Addendum #1

Project No.: ERBR-SA-75(A022)
Addendum No: Addendum #1
Date: November 19, 2020
Owner: City of Vicksburg

This addendum is to revise **Sheet VII – Intermediate Bents 2 & 3 and Sheet VIII – Intermediate Bent Details** by correcting dimensions and splice notes on the columns.

CITY OF VICKSBURG KEMP BOTTOM ROAD BRIDGE		
INTERMEDIATE BENT DETAILS		
PROJECT NO. ERBR-SA-75(A022)		
 Stantec Civil/Structural Engineers Vicksburg, Mississippi		
DESIGNED: T. ENNIS	DETAILED: J. HAGENBUSH	DATE: 10/9/2020
CHECKED: J. KELVINGTON	CHECKED: B. JOHNSON	SHEET NO.: VIII

Attachment: Sheet VII – Intermediate Bents 2 & 3, Sheet VIII – Intermediate Bent Details (both revised 11/19/20)

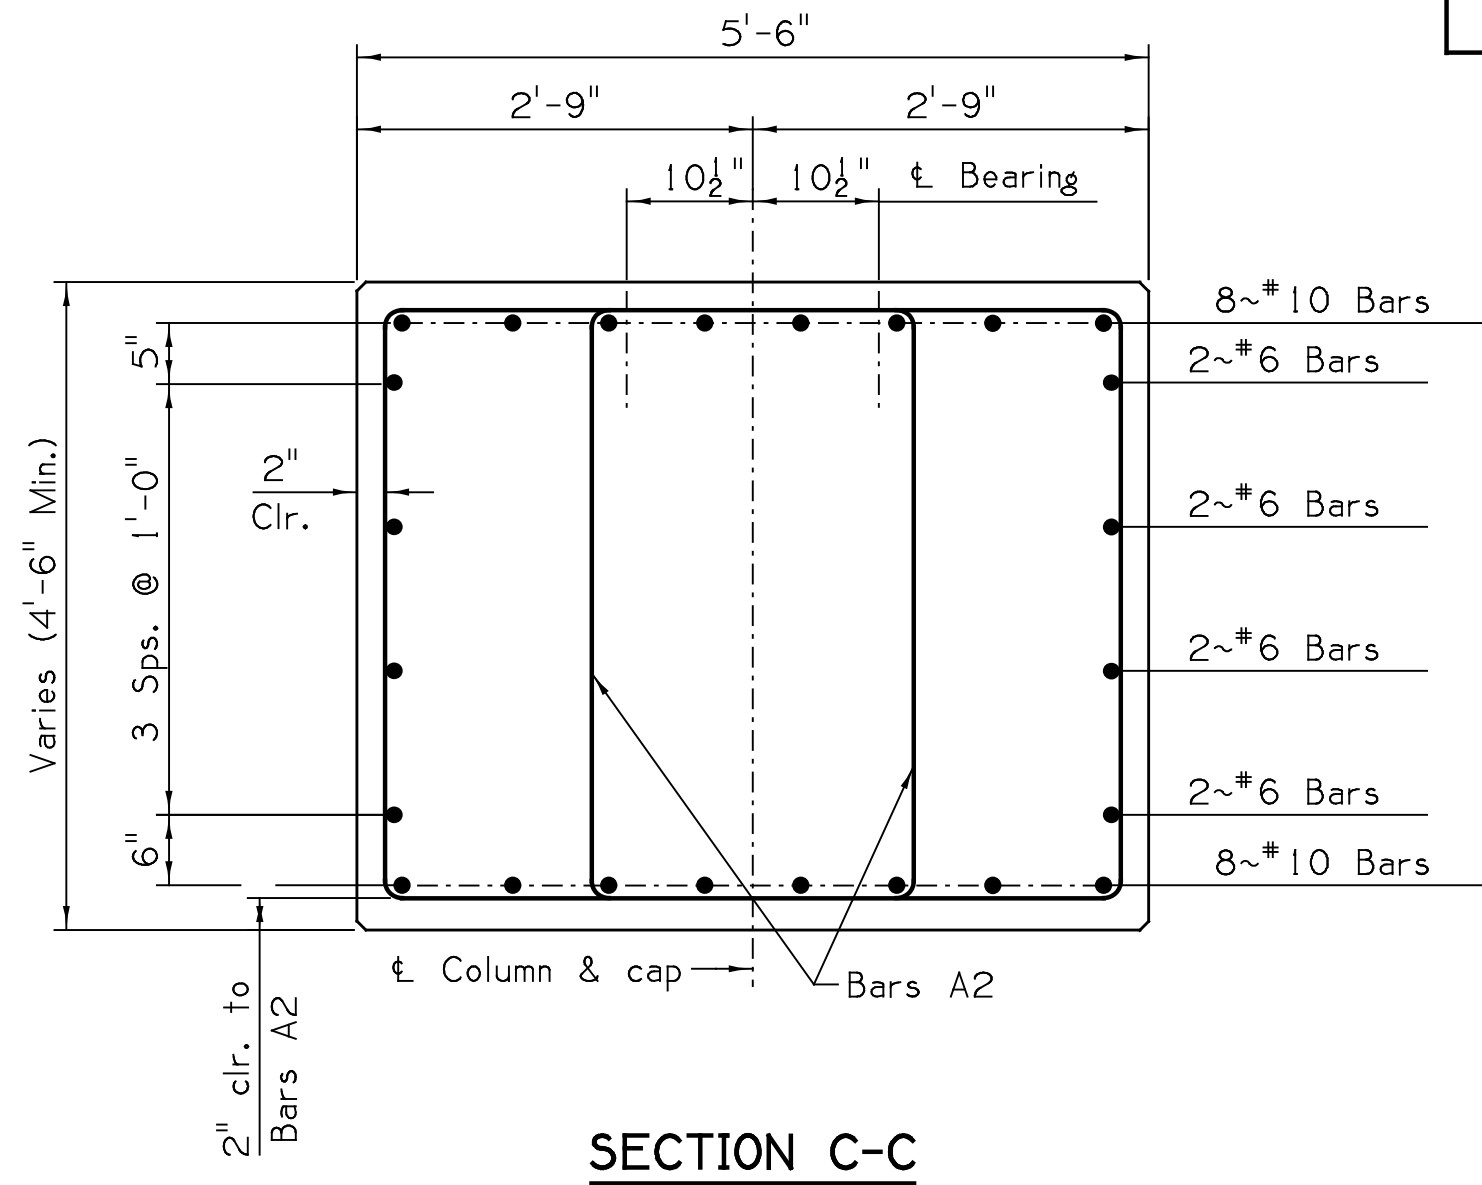
11/19/20	CORRECTED DIMENSIONS, REVISED SPLICE NOTE	JBJ
DATE	DESCRIPTION	BY
	REVISIONS

SPLICE NOTES:
* Longitudinal reinforcement lengths in drilled shafts do not include the required splice (5'-1" min.).

Longitudinal reinforcement in drilled shafts may, at the Contractor's option, be spliced using mechanical splices located 2'-0" staggered between bars.
